February 5, 2009  
NND-09-0020

Subject: Virgil C. Summer Nuclear Station (VCSNS) Units 2 and 3 Combined License Application (COLA) - Docket Numbers 52-027 and 52-028 Response to NRC Request for Additional Information (RAI) Letter No. 013

Reference: Letter from Brian C. Anderson (NRC) to Alfred M. Paglia (SCE&G), Request for Additional Information Letter No. 013 Related to SRP Section 13.03 for the Virgil C. Summer Nuclear Station Units 2 and 3 Combined License Application, dated January 6, 2009.

**SRP Section: 13.3 – Emergency Planning**

Figure 7-3. Congestion Patterns at 2 Hours after the Order to Evacuate (Scenario 1)

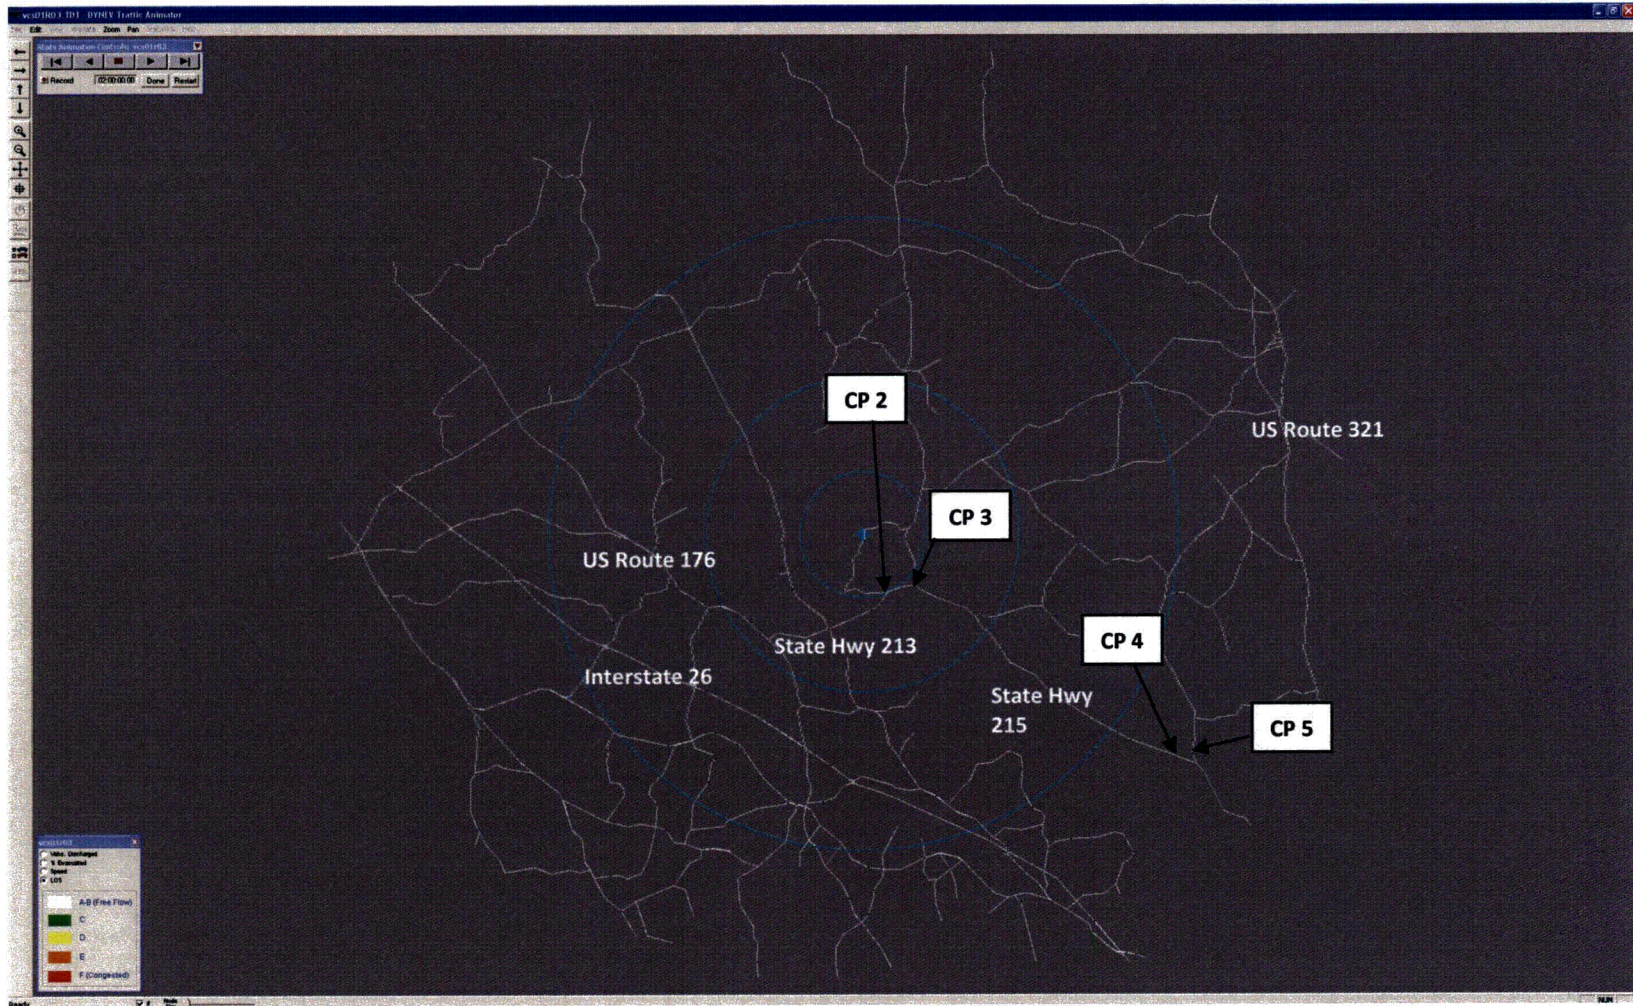
Queuing and delay times are discussed in Appendix C, "Traffic Simulation Model: PC-DYNEV," but queuing locations and estimated delay times are not indicated on the maps in Figures 7-3, "Congestion Patterns at 2 Hours after the Order to Evacuate (Scenario 1)," and Figure 7-4, "Congestion Patterns at 2 Hours after the Order to Evacuate (Scenario 12)." Provide maps that include queuing locations and estimated delay times.

Figures 7-3 and 7-4 have been revised as attached and will be included in a future revision of the ETE report. The major roads in the study area have been identified on the map. The major congestion points in the study area have been labeled with an identification number (CP # = Congestion Point #). Table 7-3 (attached) provides a description of each congestion point and the link from Figure 1-2 (RAI 13.03-3) corresponding to that area of congestion. Estimates of the average delay in minutes per vehicle are provided in the Table 7-3 for each of the congestion points. The delay presented is over the previous 10 minutes of simulation. For example, Figure 7-4 shows the congestion patterns at 2 hours after the Advisory to Evacuate for Scenario 12. The average delay for each link provided in the table (column 6) applies to the 10-minute time interval from 110 to 120 minutes after the Advisory to Evacuate. Therefore, the vehicles occupying the link from node 168 to node 8 experience an average delay of 1.8 minutes during this 10-minute interval.
